Product Change Notification - SYST-07WZKS691

ERRATA - SAM DA1 Family Silicon Errata and Data Sheet Clarifications

SAM DA1 Family Silicon Errata and Data Sheet Clarification

2.3 Schematic Checklist - Crystal Oscillator (Chapter 41 of the Device Data Sheet)

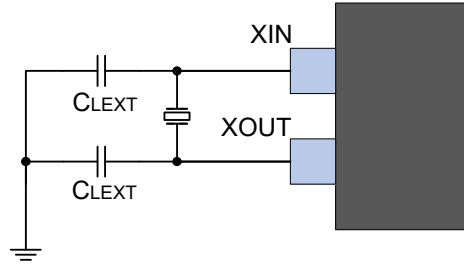
The load capacitor values shown in figure 41-6 and table 41-5 should not be used. C_{LEXT} should be calculated from the Load Capacitance Equation listed below. The corrected information is shown in **BOLD** type.

Load Capacitance Equation

$$C_{LOAD} = ([C_{XIN} + C_{LEXT}] * [C_{XOUT} + C_{LEXT}]) / ([C_{XIN} + C_{LEXT} + C_{LEXT} + C_{XOUT}] + C_{STRAY})$$
